## COUNCIL ASSESSMENT REPORT

<b>Panel Reference</b>	PPSSSH-7
<b>DA Number</b>	DA-632/2019
<b>LGA</b>	Canterbury Bankstown Council
<b>Proposed Development</b>	<i>Detailed development approval on part of proposed lot 2: Demolition of existing structures, remediation of the site, removal of trees, construction of two (2) industrial buildings with five (5) warehouses and distribution centres (with ancillary office space, loading docks, car parking) and new access road 24 hour operation 7 days a week and associated pylon sign. The remainder of proposed lot 2 is a concept only and is subject to a future development consent. Consolidation of 6 existing lots and re-subdivision into 2 lots.</i>
<b>Street Address</b>	1 Monier Square & 220, 236 & 246 Miller Road, Villawood
<b>Applicant/Owner</b>	Applicant: Logos Property  Owners: Perpetual Trustee Company Limited (1 Monier Square & 220 & 246 Miller Road, Villawood) and Toll Properties Pty Ltd (236 Miller Road, Villawood)

## **DA-632/2019 ASSESSMENT REPORT**

Figure 1 Excerpt of Landscape Plan (showing tree removals on southern boundary)

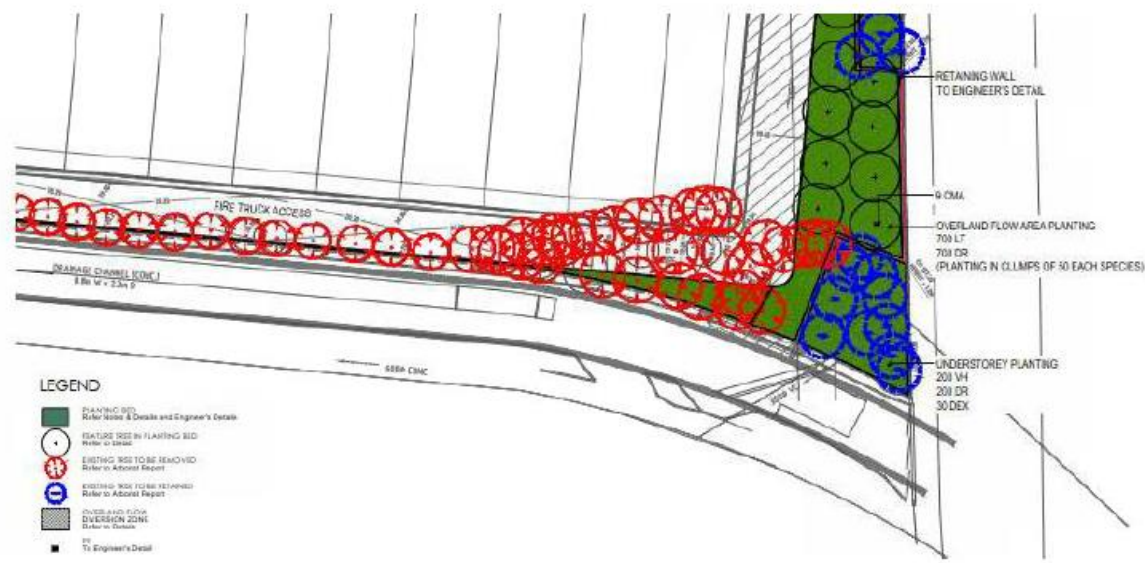
As the above table demonstrates, the proposal is seeking a variation to the riparian setback specified in clause 2.7 of BDCP 2015 – Part B3.

The development proposes a building setback of between 8.6m and 11.5m to the bank of the drainage channel with an increase in width and area of native vegetation from around 3m to 6.15m. The application has been reviewed by Council's Biodiversity Officer and has been found to be satisfactory with a condition of consent to ensure that the recommendations of Riparian Management Advice prepared by SLR June 2020 are incorporated into the development.

- A narrow belt of planted Black Tea-tree *Melaleuca bracteata*, which stretches along most of the southern boundary and occupies a width of approximately 0.5 m to 1 m (see **Photo 1**). These trees are identified for removal in the landscape plan (see **Figure 1**);
- a stand of planted Swamp Oak *Casuarina glauca* in the south eastern corner of the site, near the Miller Road entrance (see **Photo 2**). Most of these trees are identified for removal on the landscape plan (see **Figure 1**), with a small number of trees (including Spotted Gums) to be retained adjacent to Miller Road.

Council's biodiversity officer accepts the recommendations of the Riparian Management Advice prepared by SLR June 2020 and considers the proposed extension, revegetation and maintenance of the riparian corridor to be a good outcome and consistent with the intentions of Clause 2.7 of BDCP 2015 – Part B3.

A variation to Clause 2.7 of BDCP 2015 – Part B3 is therefore considered to be reasonable and justified in this case.
